Access Compliance Report

Public Rights-of-Way

Intersection ID: 26371	Main Street: BEVINGTON_PL	Cross Street: HEMINGFORD_CT	Location: NE
ADA ID: F30E44EF7249	Ramp Type: BlendTrans2	Initial Pass/Fail: Fail	Overall Compliance: No
		Severity Score: 25

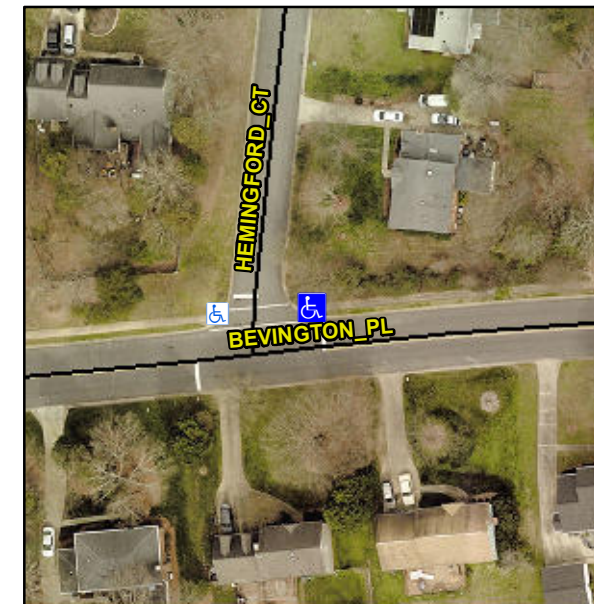
Not Found, R304.5.3

Compliance	Description	Data	Compliance	Description	Data
N/A	Ramp Length (in)	38.0	Yes	BlendTrans Slope (%)	1.2
Yes	Ramp Width (in)	48.0	No	BlendTrans XSlope (%)	15.0
N/A	Flare Type LT	N/A	N/A	Flare Type RT	N/A
N/A	Flare Slope LT (%)	N/A	N/A	Flare Slope RT (%)	N/A
N/A	Flare Traversable LT?	N/A	N/A	Flare Traversable RT?	N/A
N/A	Landing Length (in)	N/A	N/A	DWS Provided?	N/A
N/A	Landing Width (in)	N/A	N/A	DWS Contrast?	N/A
N/A	Landing Slope (%)	N/A	N/A	DWS Length (in)	N/A
N/A	Landing X Slope (%)	N/A	N/A	DWS Full Width?	N/A
N/A	Landing Curb? (Y/N)	N/A	N/A	DWS Offset (in)	N/A
N/A	Shared Landing?	N/A			
N/A	Gutter Ponding?	N/A	N/A	Gutter Slope (%)	N/A
N/A	Gutter Lip Ht (in)	N/A	N/A	Gutter X Slope (%)	N/A
N/A	Painted X Walk1?	Yes	N/A	Painted X Walk2?	No
	X Walk 1 Direction	To W		X Walk 2 Direction	To S
	X Walk 1 Width (in)	108.0		X Walk 2 Width (in)	N/A
	X Walk 1 Slope (%)	4.5		X Walk 2 Slope (%)	2.2
	X Walk 1 X Slope (%)	13.1		X Walk 2 X Slope (%)	6.0

Remove & Replace Curb Ramp With Two New Directional Ramps or Equivalent.
